(NEW): Q+A QUESTIONS + ANSWERS – Questions submitted through October 1, 2021

(NEW): Q+A QUESTIONS + ANSWERS – Questions submitted through September 24, 2021

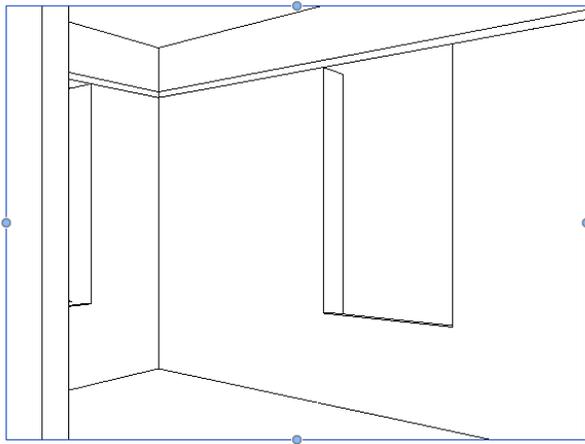
Q: Are the columns in the space concrete columns?

A: YES, all of the columns are concrete.

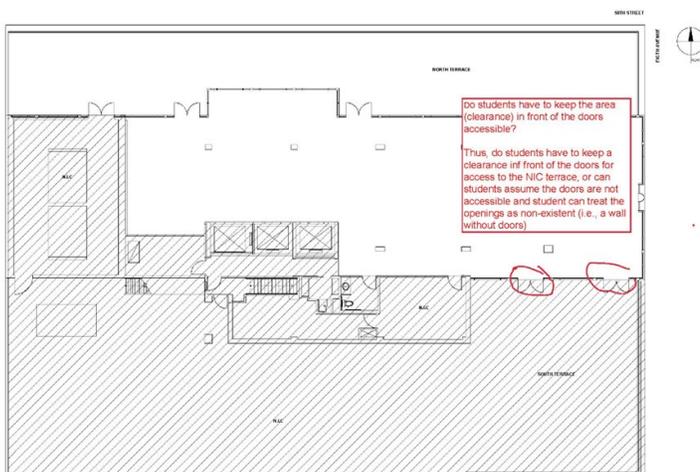
Q: Given previous answers to the HVAC, we assume we may remove the window sill/shelf/bench on the North and East walls of the 7th floor for the purposes of this competition?

Q: In lieu of this HVAC system, we will assume and account for another type of perimeter HVAC system in its place.

A: This should remain as is.

A: Any additional HVAC is left to the discretion of the student.

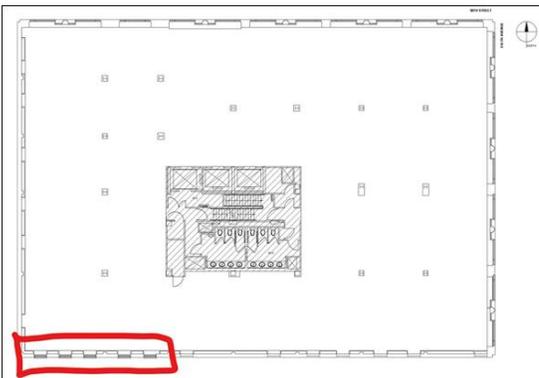
Q: In piercing the slab between the 7th and 8th floor to place the staircase, are there any limitations in the area of the opening? (other than the logical location of structural beams between columns). Should the opening between 7th and 8th floor be limited to the footprint of the monumental staircase? or can we allow for a larger opening that connects spatially and visually both floors?

A: There are no limitations here other than working within the columns as you have identified.

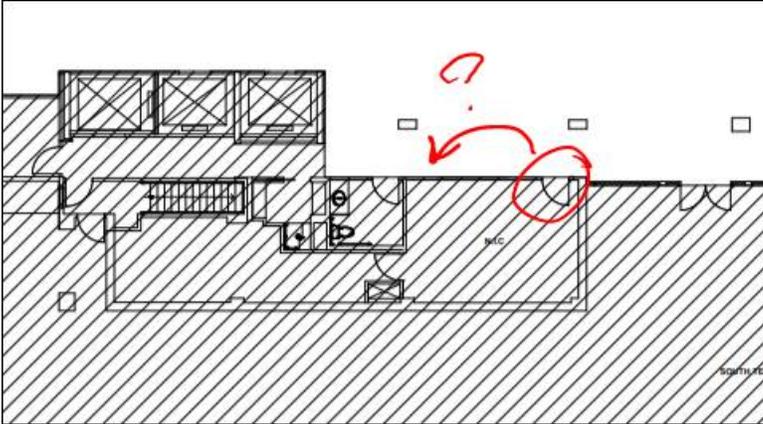
Q: What is allowed on the 8th floor north terrace? Can the floor of the terrace be covered in landscape materials like gravel, wood planking, stone pavers, plants, trees, etc.

A: What will be reviewed and evaluated on the exterior terrace are the applications/settings of furniture provided for the employees. There is no expectation or evaluation for design of the landscaping or architecture – especially since this is an interior design competition. Your students may choose to do this if they wish; however, any plants/trees must be in pots – not dug into the floor.

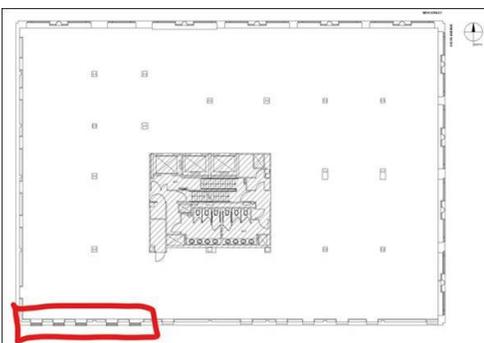
Q: For clarification, under the requirements for the Resource Centers. The quantity of resource centers is 2 (one for each floor) with requirements of 1 copier/printer, 1 large format printer, a recycling center, etc.

Q: Does this mean these requirements are all included in each Center?

A: Yes, those are the requirements for (both) locations.

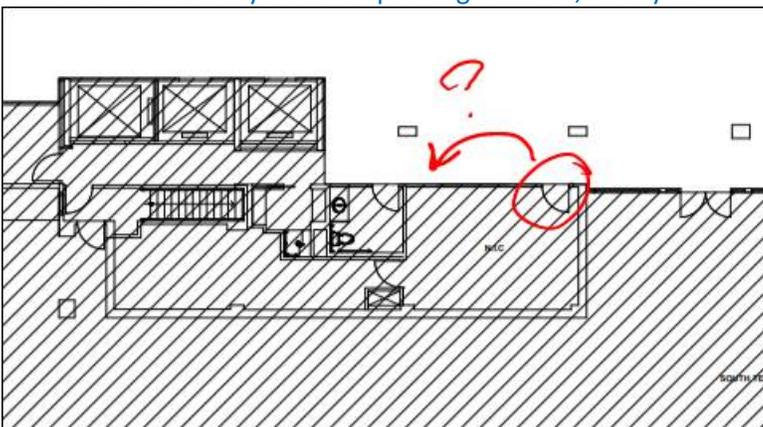
Q: Are we able to change any of the HVAC or make any structural changes?

Q: Are we able to change out existing windows and doors in the building?

A: No structural changes may be made. The HVAC is not part of the evaluation for this competition. Students may make any design decisions or assumptions for HVAC.

A: NO windows may be changed. The only interior door location that may be changed is this one that was stated in a prior answer to Q+A since it opens into a NIC area:

If this is the location you are requesting to move, then yes.

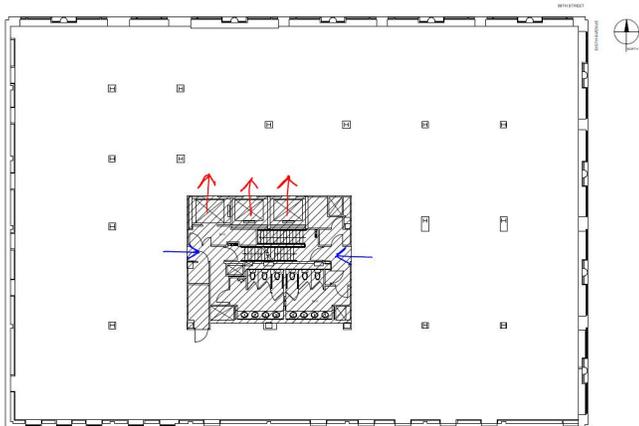
Q: Are we allowed to apply materials to the columns and beams?

A: YES, if this meets your design intent. Columns may be covered or left unfinished.
